FINDING OF EFFECT MEMORANDUM

*Prepared by ICF at the request of Marin Housing Authority in partial fulfillment of Section 106
Review requirements*

Historic Property: Golden Gate Village
Project Name: Defensible Space Vegetation Removal
Street Address: 101–429 Drake Avenue and 1–99 Cole Drive, Marin City
Project Applicant: Marin Housing Authority, County of Marin
Lead Agency: County of Marin
Contact: Evan Smith

Attachment 3.3 - Fire Inspection #3 (13 August 2018)

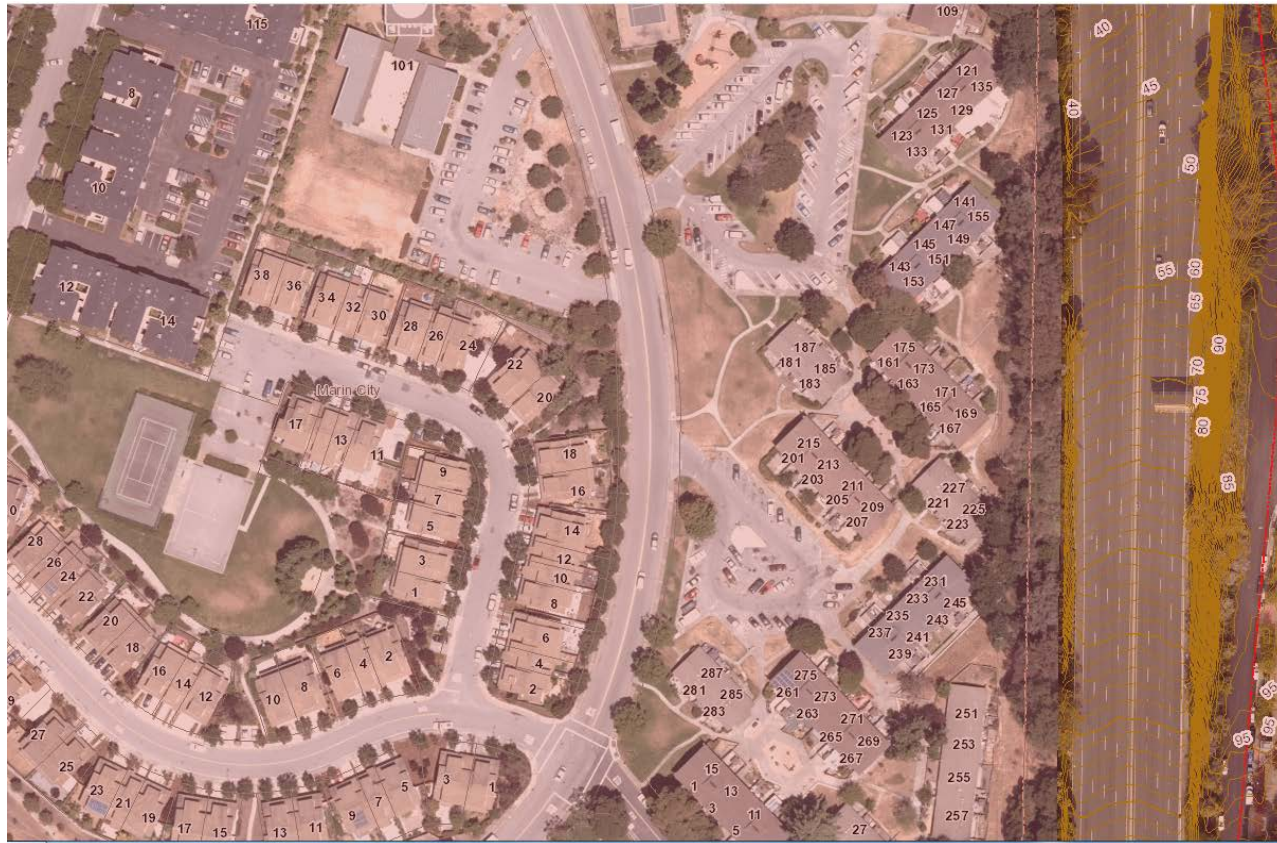
1. Remove broom between 419 Drake and office at 429.
2. Knock down and spread out chip piles behind 419
3. Remove dead and down material immediately above retaining wall consider erosion control and minimize ground disturbing
4. Remove brush, broom 10' from block wall behind 49 Cole
5. Cut broom and brush between 49 Cole and Appt. 39 to "old cut line"

6. Work with residents to clean up behind 251-257 Cole dr. remove licorice plant and yard debris
7. Ensure adequate fuel reduction behind building off 100 and 200 lot adjacent to Freeway. Combination of residents cleaning up yard and yard debris cutting back brush/broom at least 10' from fence lines.

TREATMENT RECOMMENDATIONS

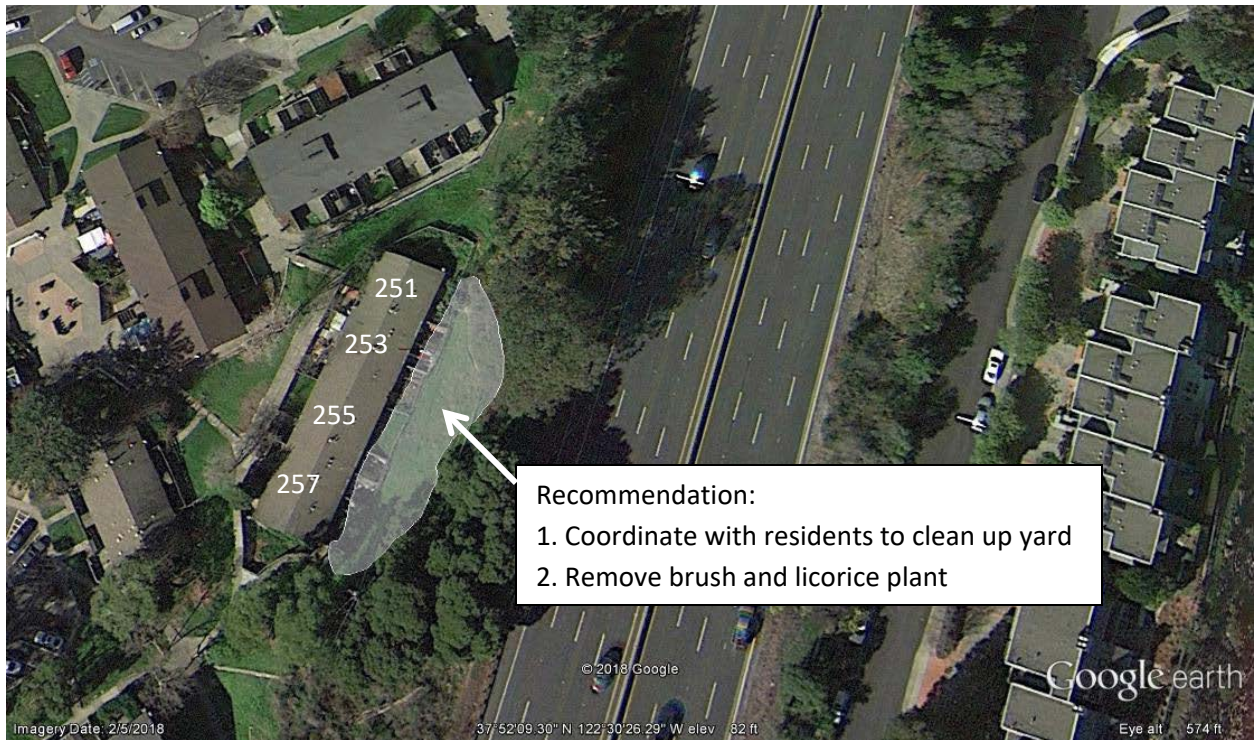
Recommendation:

1. Remove small diameter Eucalyptus. Cover cut Eucalyptus stumps with landscape fabric to prevent re-sprouting.
2. Remove large Eucalyptus trees to eliminate material falling on roof and decks. Cover stumps.
3. Remove Broom

1. Remove brush and broom 20' from block wall behind 49 Cole.
2. Cut broom and brush between 49 Cole and Apt. 39 to the "old cut-line" .

Condition: GGV shall work with MCFD to determine an acceptable height to which it could cut back and/or mow the vegetation from the retaining wall without completely removing it. Given the overall design of the historic landscape and the presence of specific plantings in this area historically, it would be appropriate for GGV to cut back and/or mow this vegetation without removing it completely. Vegetation that is compatible with Halprin's design intention could include a mixture of low-growing species in this area, rather than sowing a homogenous 25-foot strip of mowed lawn. GGV should engage a qualified landscape architect and historic preservation consultant to identify a fire-wise and compatible plant palette with the historic landscape for a long-term solution for this area of the property.

Condition: GGV shall work with MCFD to clarify the dimensions of "small diameter" eucalyptus trees. *Eucalyptus viminalis* can range from small to very large trees. The original design intention should be maintained of providing a woodland setting extending from the Marin Headlands to the south with clusters of approximately 6 or less trees.

Condition: GGV shall work with MCFD to determine the removal of eucalyptus trees south and east of building 69 of only those trees that pose a threat to the building. Given the design intent for this area to have a cluster of canopy trees,

Condition: If GGV cuts back the broom and brush between building 49 and apartment 39 between the block wall at the base of Highway 101 and outside the looped sidewalk surrounding apartments 39–45 so as not to disturb hedges, this action would both meet the intention behind the MCFD’s recommendation and meet the Secretary of the Interior’s Standards for Rehabilitation.
